7 Brew Drive-Thru Coffee 1907 SW Gatlin Blvd. Special Exception Use

Project: P24-043

Planning and Zoning Board Meeting Bethany Grubbs, Planner III August 6, 2024, Meeting

Conceptual Site Plan

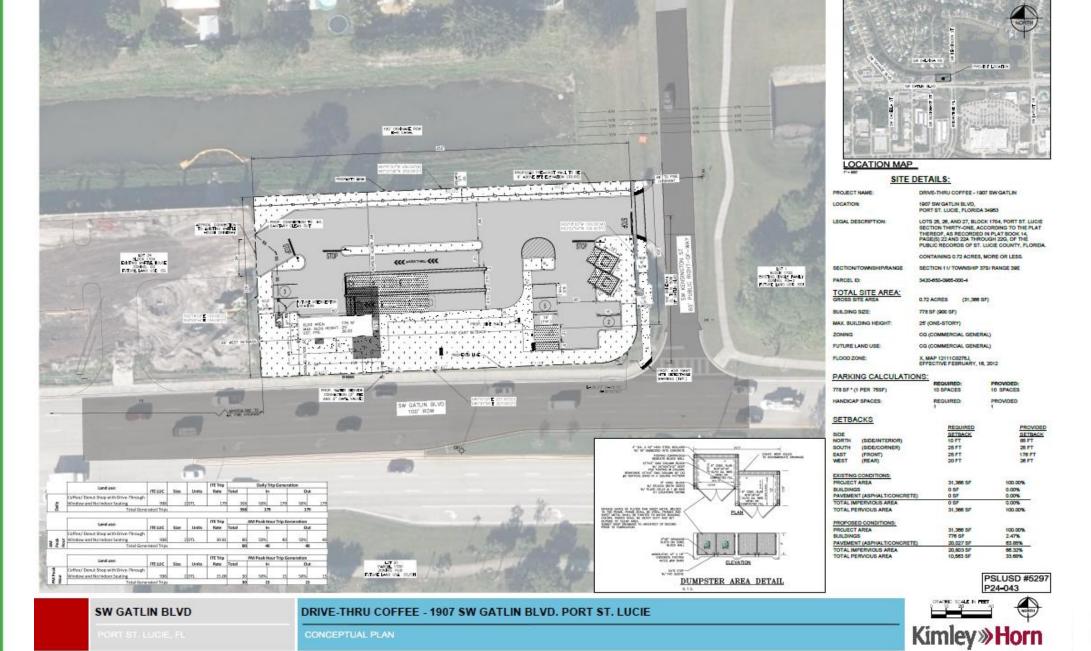
Evaluation of SEU CRITERIA	<u>FINDINGS</u>
_(Section 158.260)	
ADEQUATE INGRESS AND EGRESS (§ 158.260 (A))	The site plan demonstrates that the site has adequate ingress and egress for vehicles, the proposed development will allow for pedestrian safety and convenience. The property is located on the north side of SW Gatlin Blvd., at the corner of the intersection of SW Gatlin Blvd. & SW Kensington Street and has vehicular access along SW Kensington Street, a public roadway. There is cross-access identified on the conceptual plan.
ADEQUATE OFF-STREET PARKING AND LOADING AREAS (§ 158.260 (B))	Adequate off-street parking is provided for the proposed drive-through use. There will be no indoor dining or patron use. The site is required to have 10 parking spaces at one (1) space per 75 square feet. On-site parking will be used for employee parking only. A buffer wall will be used to screen the proposed development from neighboring residential properties to the north of the site.

ADEQUATE AND PROPERLY LOCATED UTILITIES (§ 158.260 (C))	Adequate utilities are available to service the development.
ADEQUATE SCREENING OR BUFFERING (§§ 158.260 (D) (F))	A wall is required in a landscape buffer strip where commercial, industrial, institutional, office, or public facility uses abut property to the side or rear which is designated with a residential or open space land use. The architectural wall shall be at least 6 feet in height measured from the finished floor elevation of the primary structure on the subject property. Yard setbacks and open space are adequate, to properly serve the proposed development and to ensure compatibility with adjoining properties.
SIGNAGE AND EXTERIOR LIGHTING (§158.260 (E))	No signs or outdoor lighting has been proposed for the site.
COMPATIBILITY WITH SURROUNDING USES (§§ 158.260 (H) (I) (J))	By adhering to City Codes and Regulations, the establishment and operation of the proposed use is not anticipated to impair the health, safety, welfare, or convenience of residents and workers in the City. The proposed use is not expected to generate noise or hazards because of the number of persons who will attend or use the facility. The establishment will operate year-round and is open from 5:30 AM to 10:00 PM. Public Works has reviewed the queuing analysis and found it acceptable. The proposed use is not expected to impact the neighbors or surrounding roadways. The proposed use is not expected to adversely impact surrounding properties. The building footprint is proposed at 778 sq. ft. and is adjacent to commercial uses such as a restaurant to the west of the site.
